DRAINAGE PLAN
STA. 145+00 TO 150+00

FARRINGTON HIGHWAY INTERSECTION IMPROVEMENTS
AT NANAKULI AVENUE AND HALEAKALA AVENUE
Federal-Aid Project No. STP-093-1(22)

CONTRACT CHANGE ORDER NO. 27
Attachment 1

DRAINAGE PROFILES - 1

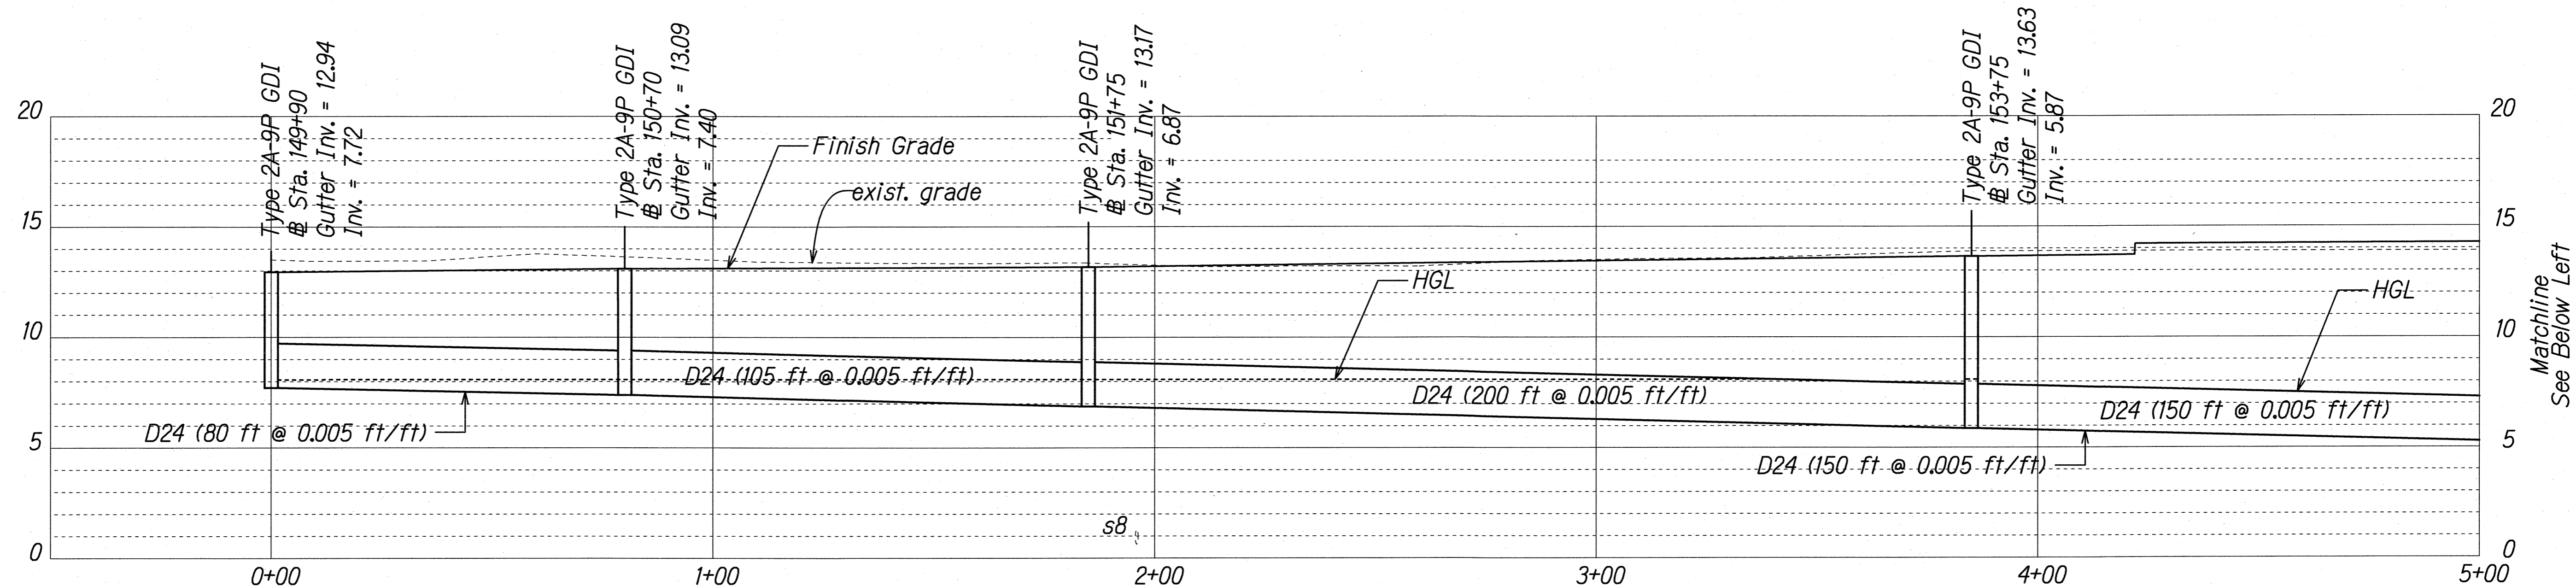
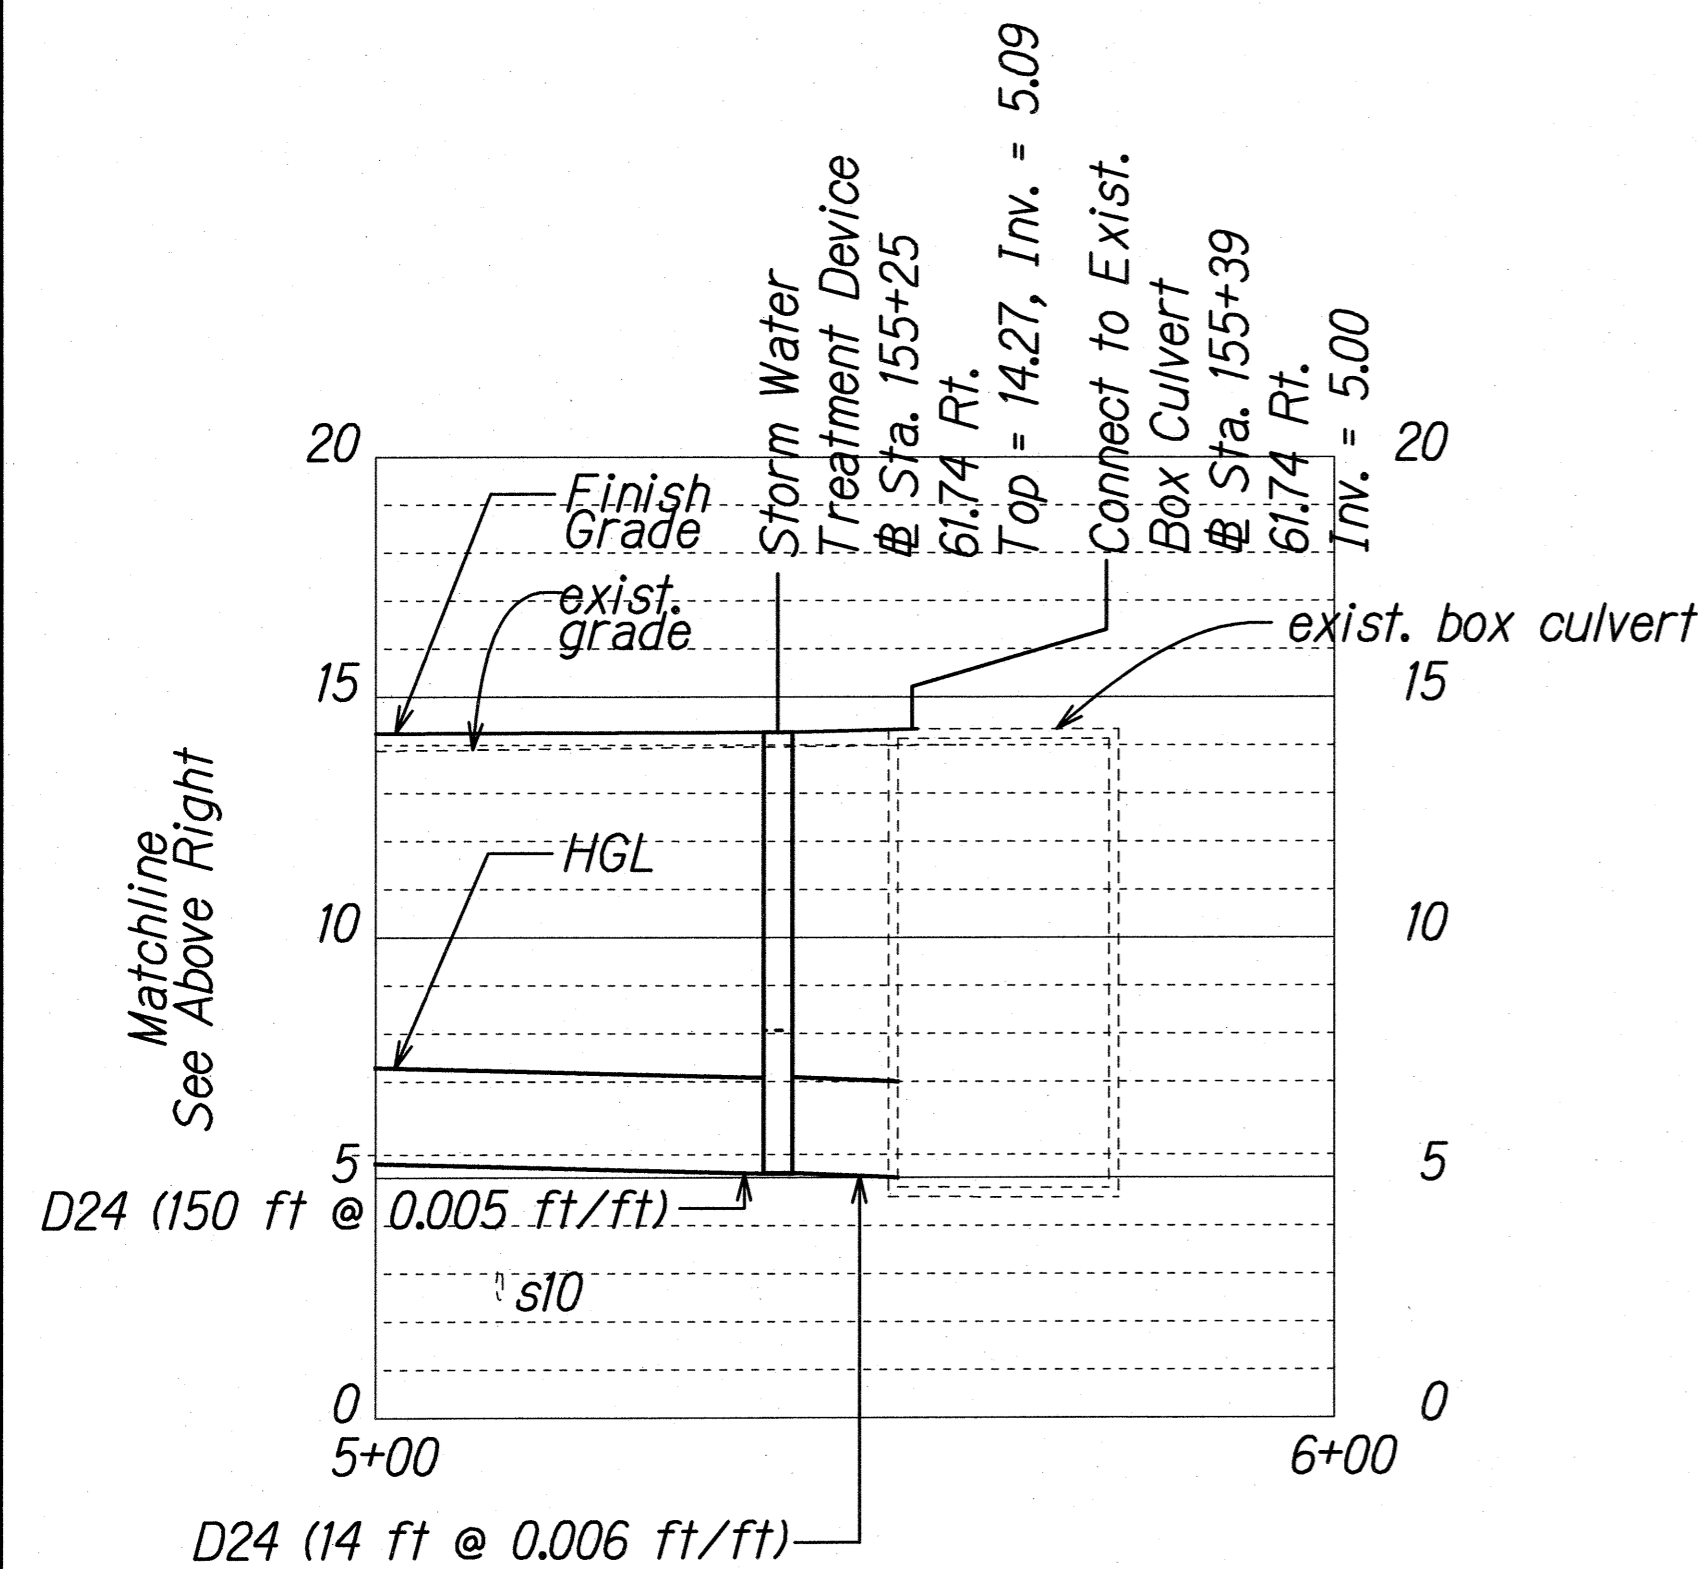
11/17/17	△ Revised Drainline "A"
4/22/15	△ Revised Drainline "A"
DATE	REVISION

DRAINAGE PROFILES - 2

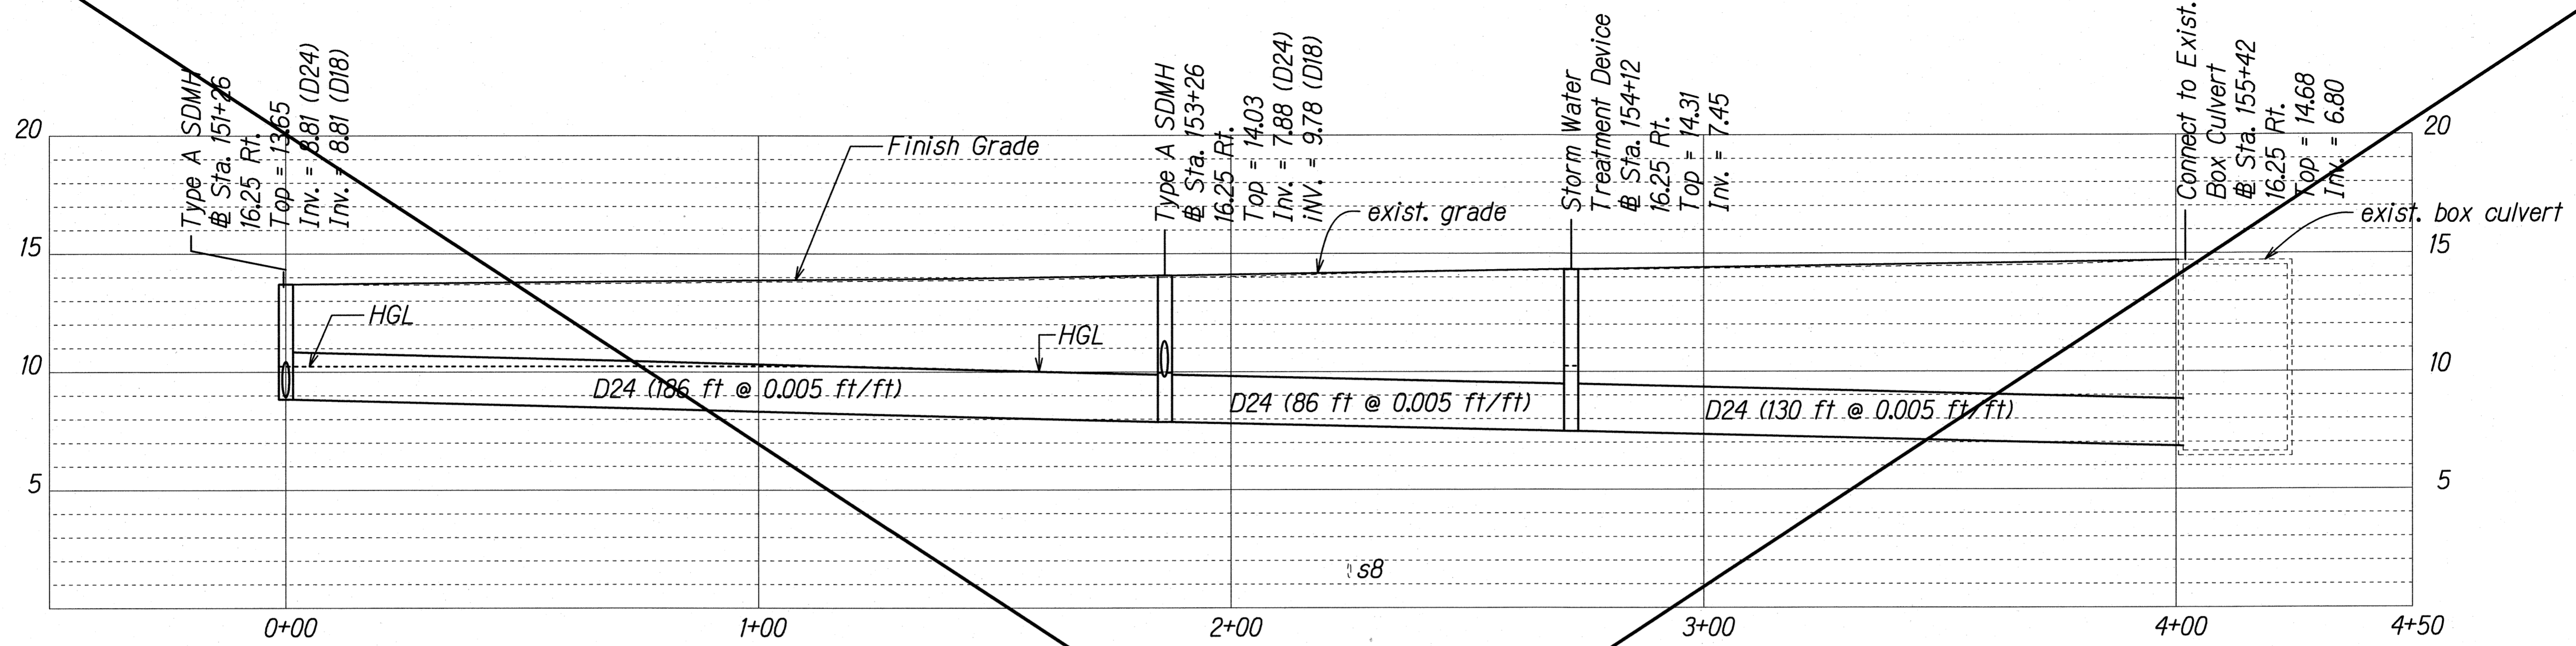
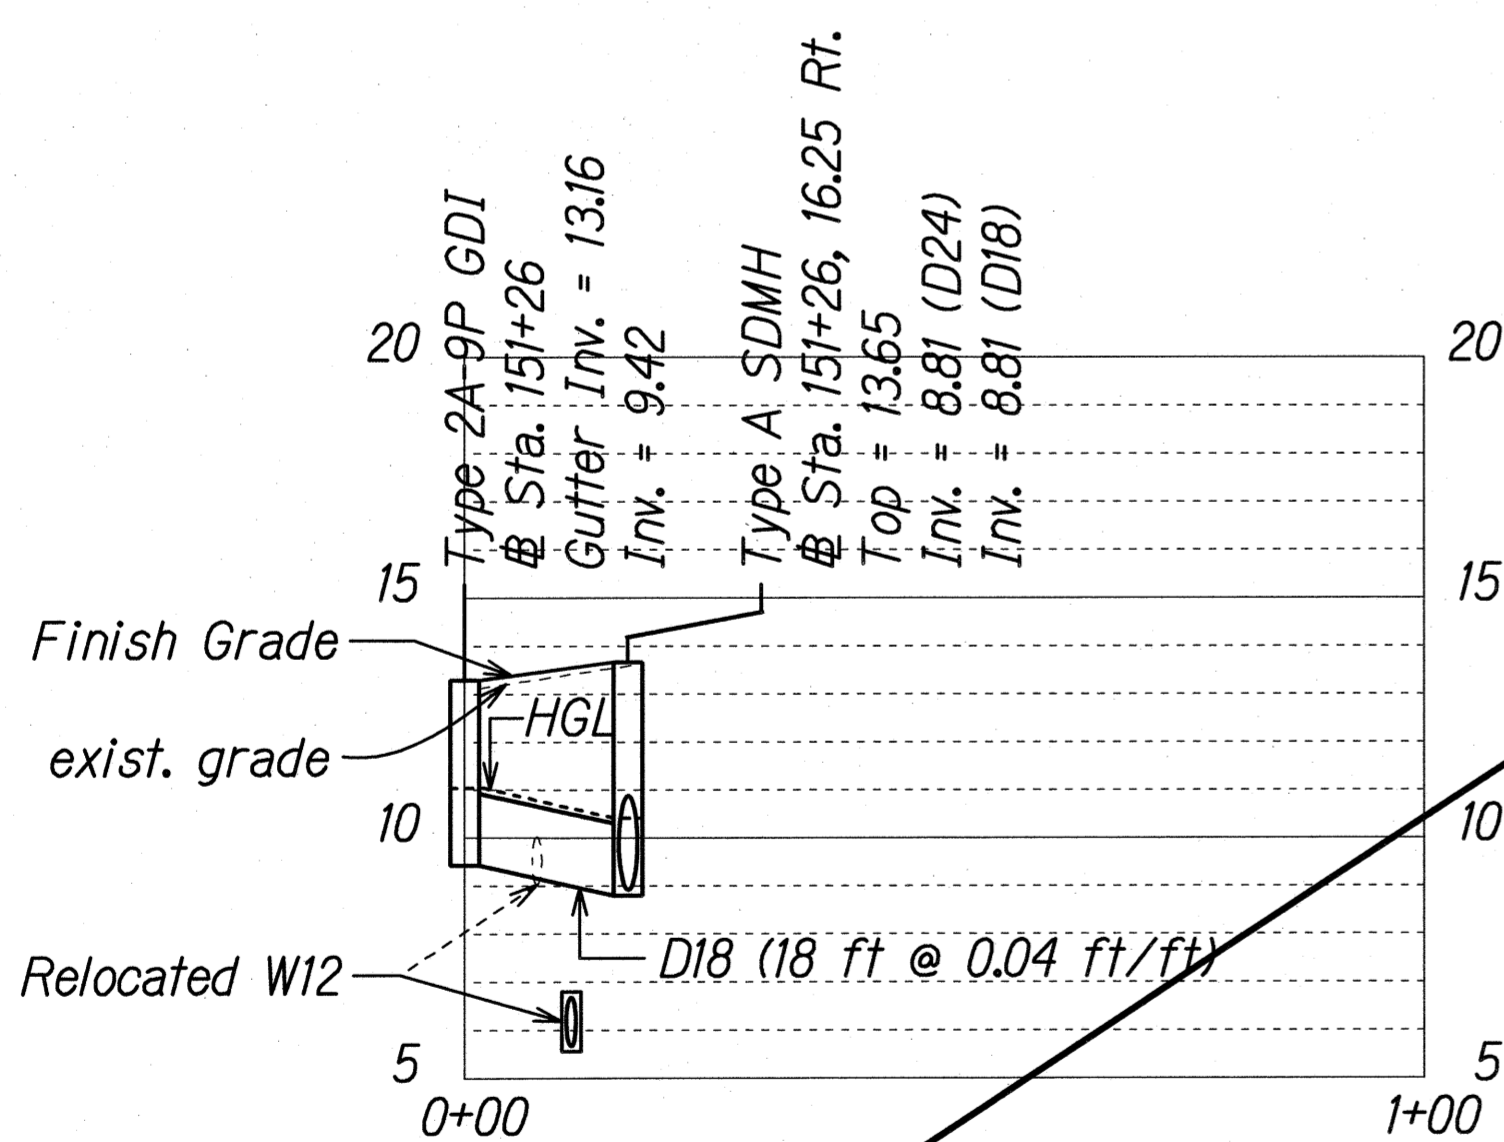
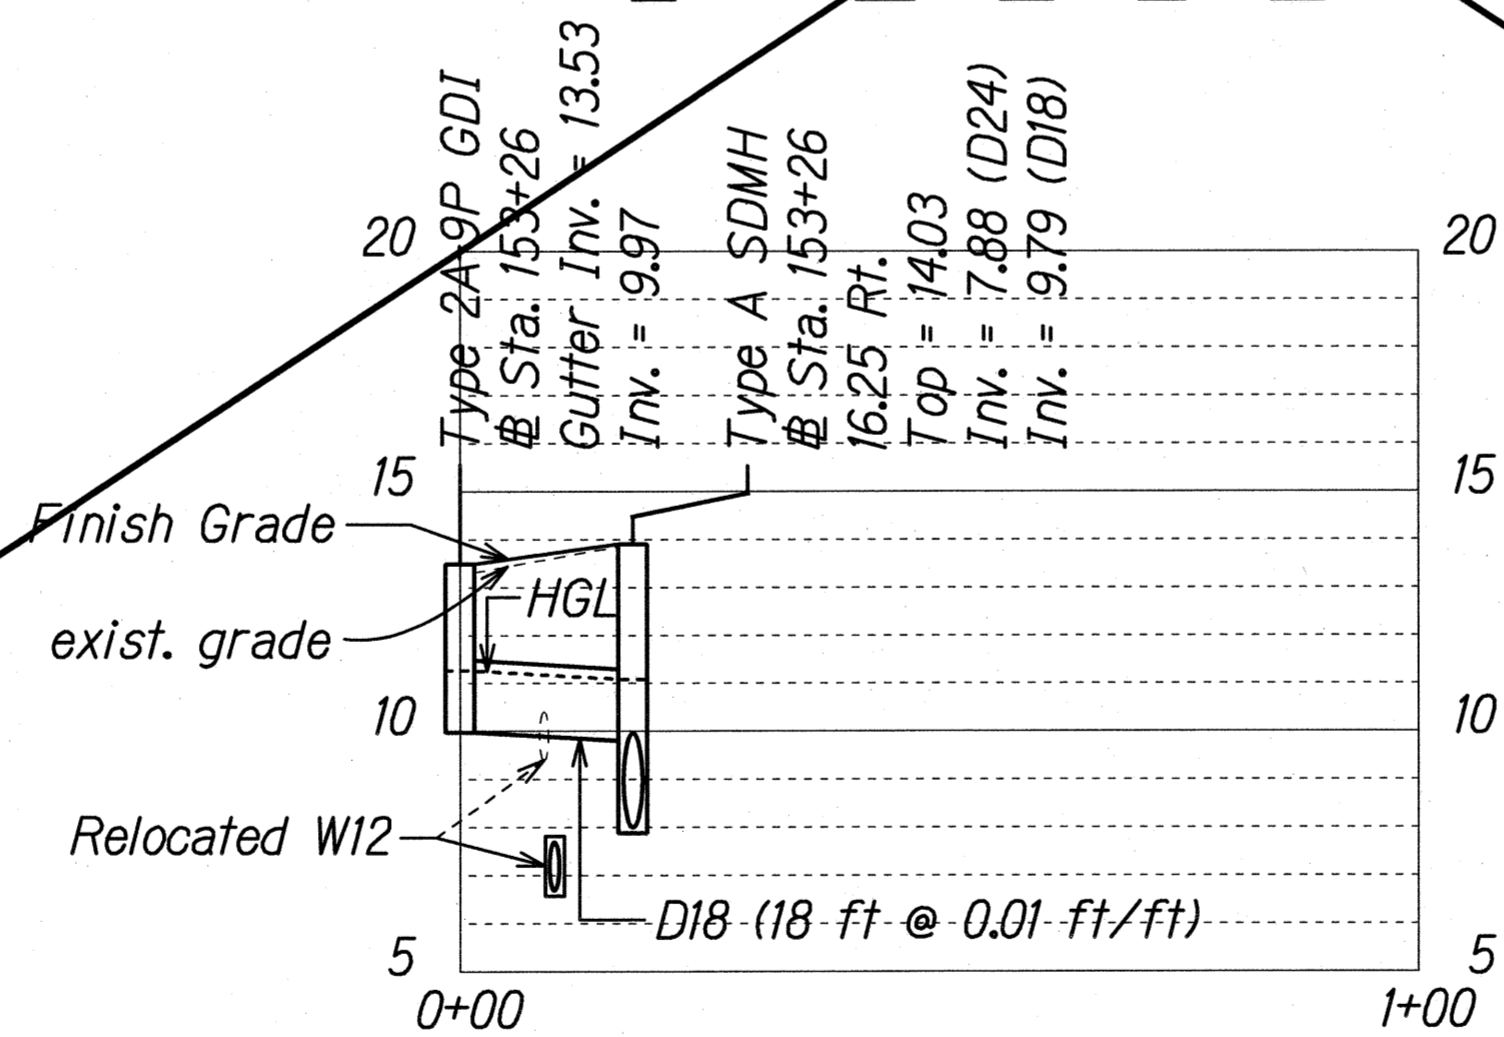
8/7/17	 Sheet Deleted
4/22/15	 Revised Drainline "B", "B-1", "B-2"
DATE	REVISION
